**OBJECTION TO DEVELOPMENT APPLICATION No. 2020/0838
PROPOSED DEMOLITION OF AN EXISTING SINGLE DWELLING HOUSE AND THE CONSTRUCTION OF
A DWELLING HOUSE INCLUDING A SECONDARY DWELLING AND A SWIMMING POOL.
PREMISES – 86 QUIRK STREET DEE WHY**

Urbanesque Planning has undertaken a review of the above application for Mr S and Mrs N HARRIS who are the registered proprietors of No. 84 Quirk Street Dee Why. No. 84 Quirk Street is the immediately adjoining property to the west of the subject site.

Figure 5: Existing sight lines from 84 Quirk Street to Dee Why coastline. Source: www.google.com/maps

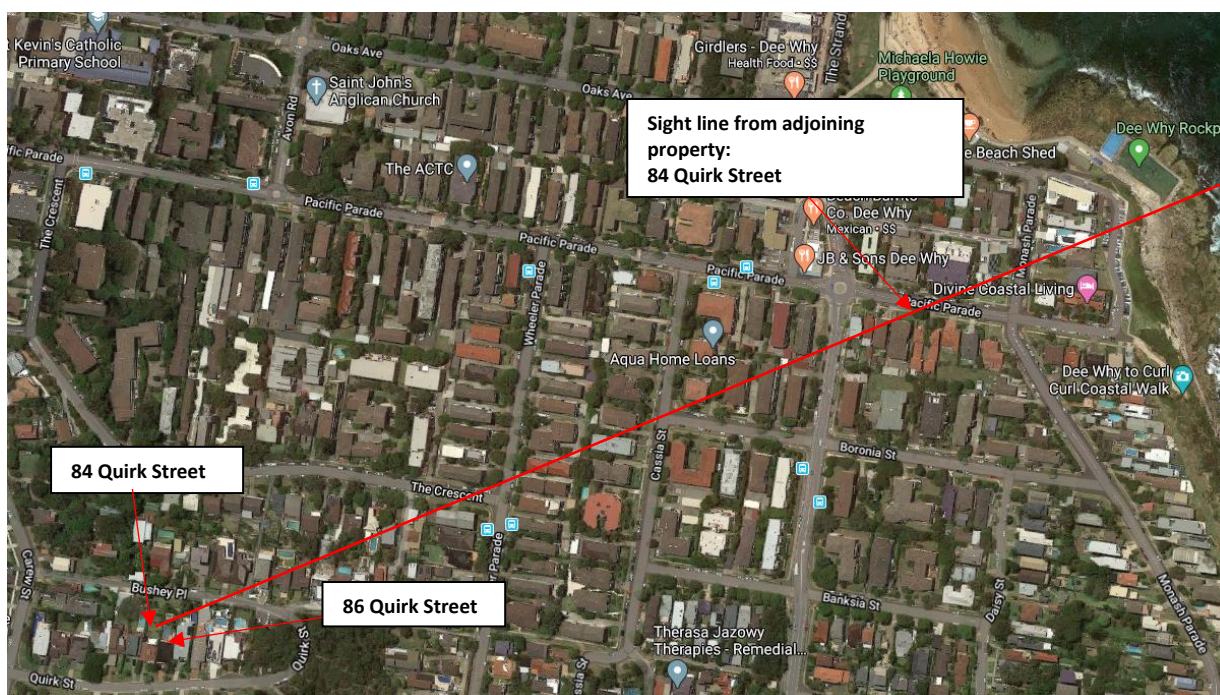
The existing sight lines of 84 Quirk Street can be seen in Figure 5. The installation of cladded stud walls along the eastern boundary and the height of the secondary dwelling will directly impede on the views enjoyed from 84 Quirk Street. We suggest that lowering the pool height will reduce the view impact to 84 Quirk Street as the proposed height is higher than that of the adjoining properties ground level. The owner has erected height poles on their own property to gauge the impact of the proposed development. The owner’s presentation is attached to this report.

The suggestion that the development will have no direct impact and there is to be no impedance of views is unfounded and incorrect. The applicant has not made any genuine attempt to provide a view loss assessment and therefore the design is incompetent.
